APPENDIX XVII
BTCA INFORMATION

DES-BEE-DOVE MINES
 PERMIT AREA

Pacificorp Electric Operations
Des-Bee-Dove Mine
ACT/015/017

Emery County, Utah
May 31, 1991

FIGURE 7

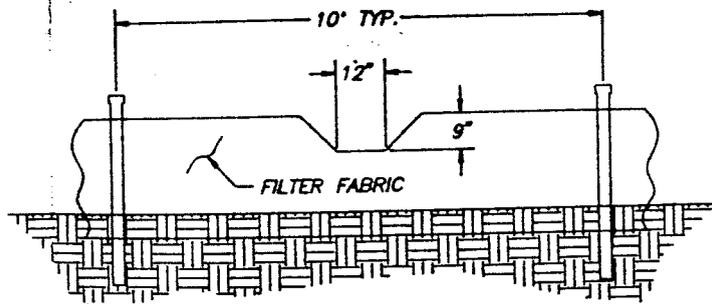
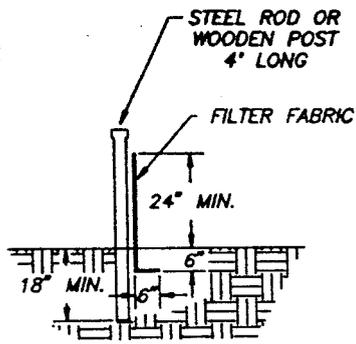
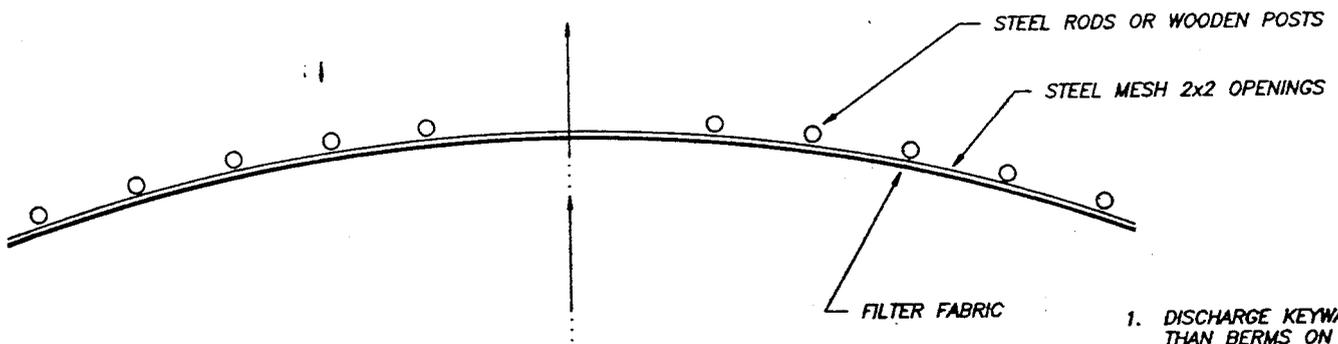
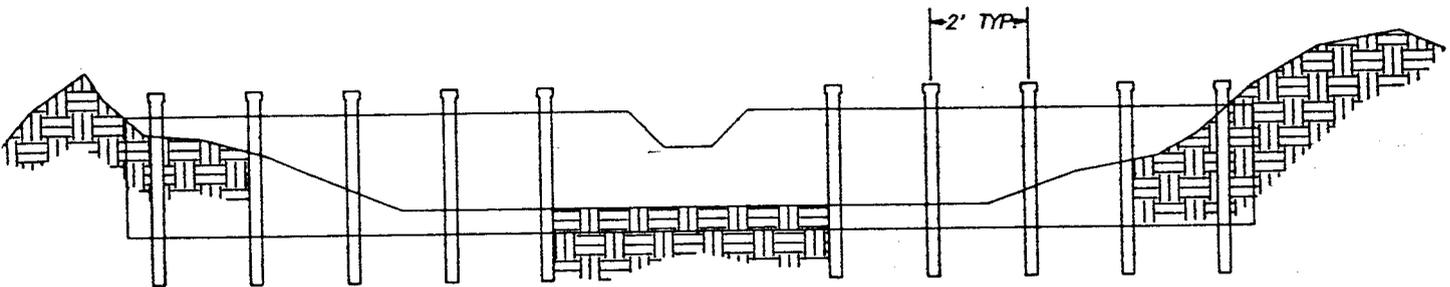
- 1) A plan for providing sediment control during construction and following construction of all stream crossings and culvert removal sites where permanent diversions will be installed;
- 2) A revised and upgraded plan for the contour furrows and berms as shown on Plate 4-1, sheet 3 of 5 to address the runoff storage capacity of these BTCA measures in relation to the 10-year, 24-hour storm runoff volume. This will verify the treatments' effectiveness in providing treatment for all areas not draining to the sediment pond. This must be included in a BTCA Appendix showing all areas treated with BTCA measures other than sediment ponds; and

During and following construction of stream crossings and culvert removal sites where permanent diversions are installed, sediment structures will be placed downstream to contain any sediment from leaving the area and contributing to the streamflow's suspended solids. The sediment structures will be siltfence, backed by strawbales or metal mesh (See Figure 7 for details). Volume and frequency of the sediment structures will be based on a 10 yr./24 hr. storm event using the following formulas:

DRAWN BY:	K. LARSEN	CS1284A
SCALE:	1" = 40'	
DATE:	MARCH 5, 1991	SHEET 1 OF 1 REV.

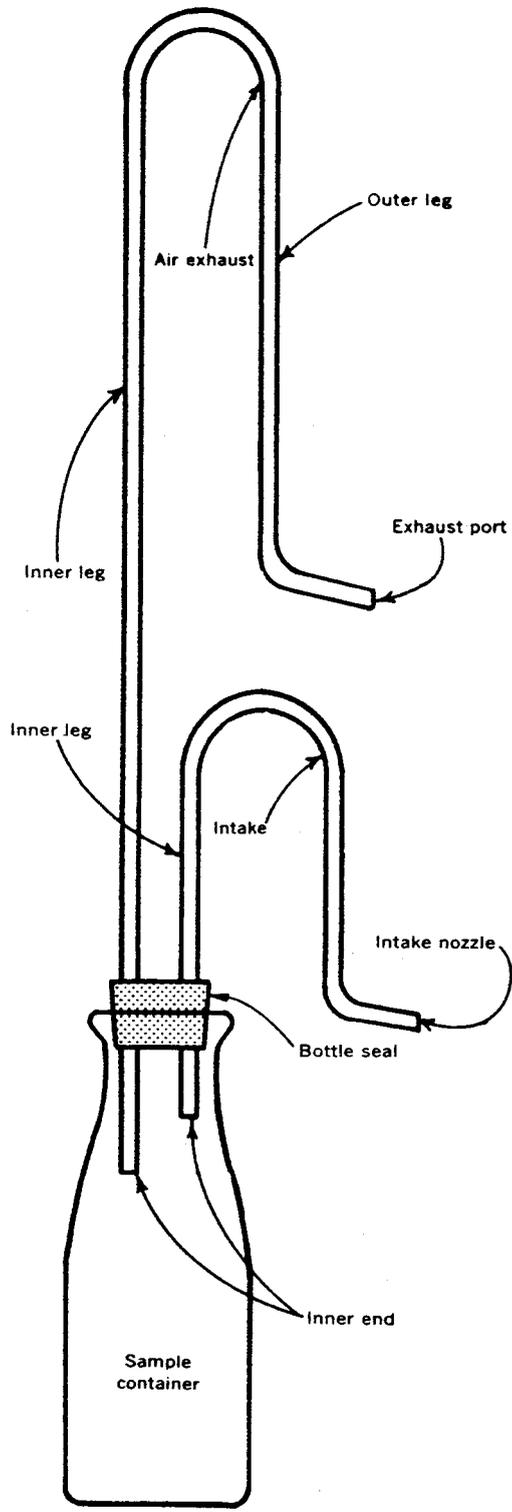
- 3) The assessment of the runoff water quality must be included as a design criteria for the test plot study. The data must be interpreted and included as part of the BTCA appendix upon submittal following test plot implementation. The plan must identify the surface water quality and quantity parameters to be monitored, sampling frequency and site location.
